ITB #23-015
Cemetery Road WWTP Ponds
Expansion

Addendum #2
Pre-Bid Meeting Minutes/ Q's & A's

CITY OF SEBRING
CEMETERY ROAD WWTP NEW PONDS
HAUL ROAD SKETCH

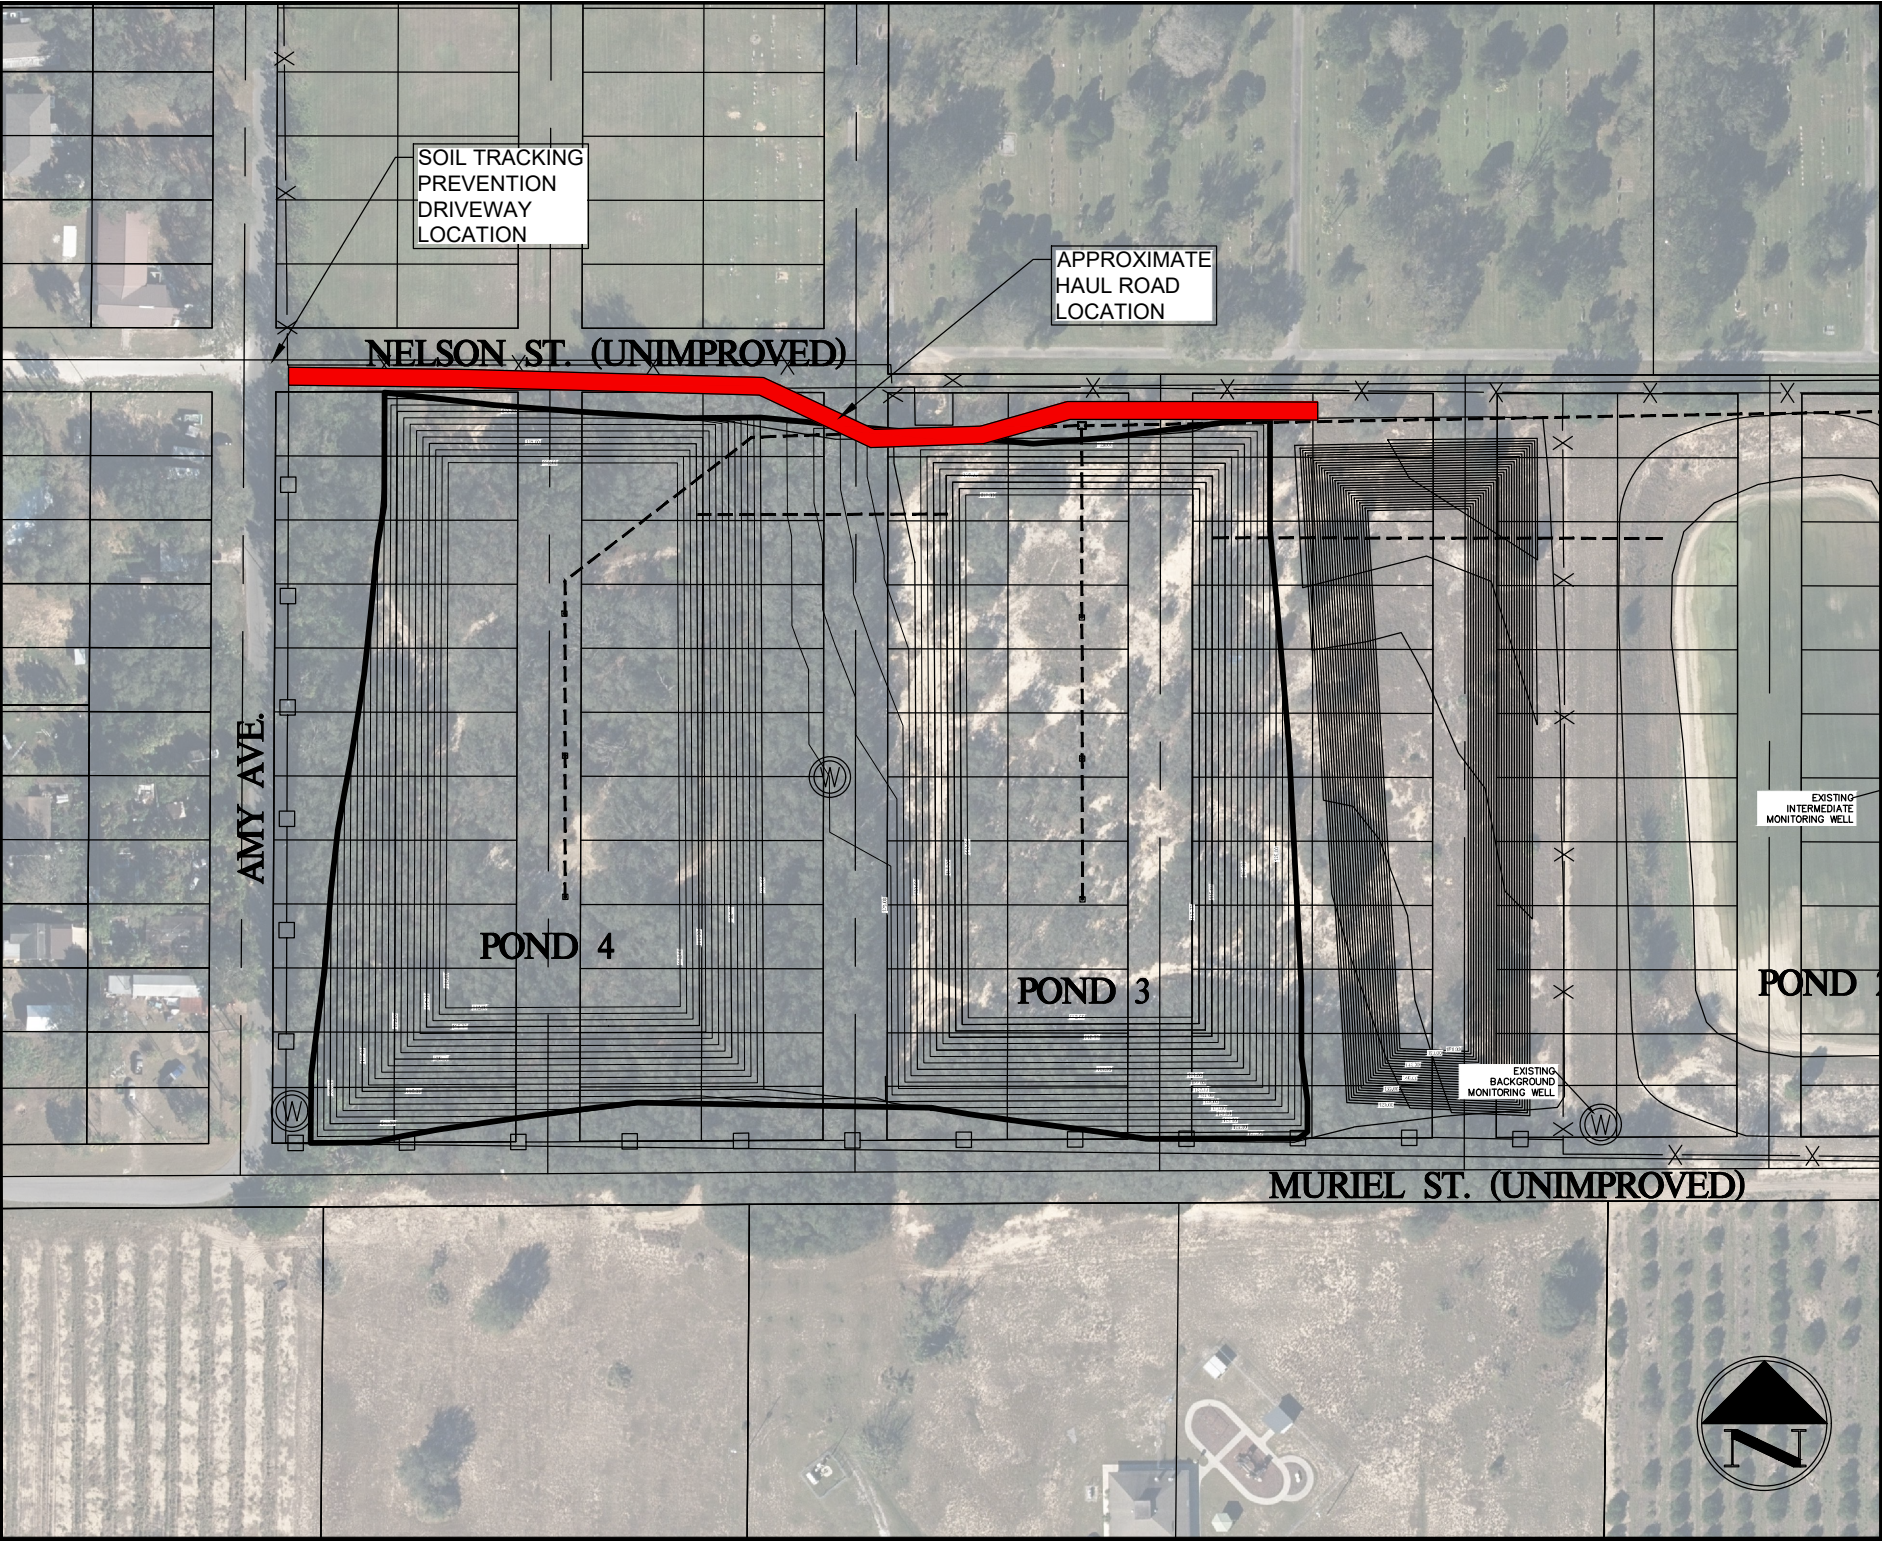
Q: Where is the location for the proposed haul road?

A: The haul road is to be located at the northwest corner of the project area. A sketch has been attached to this response.
